MIAMIBEACH
REVIEWED FOR
CODE COMPLIANCE

GNC #2841 Plan Review/Permit Corrections Report: BC1808816
1698 Alton Road, Unit #200, Miami Beach, FL 33139

RE: 1700 & West POOL PERMIT RESPONSE COMMENTS

POOL EQUIPMENT YARD LAYOUT PLAN

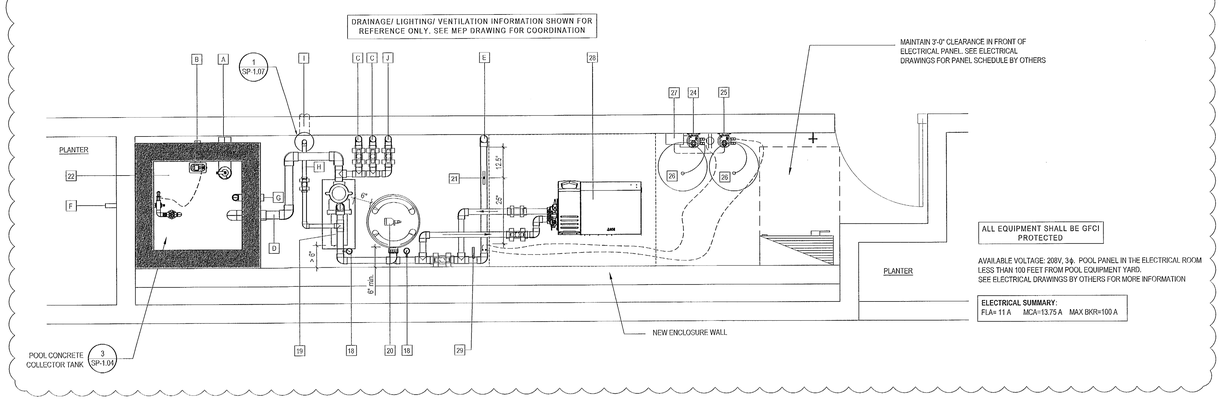
2. It is recommended that Pool circulation pump should be equipped in the inlet side with approved –type hair and lint strainer
Response: Whisperflo pumps come with integral strainer. See attached documentation.
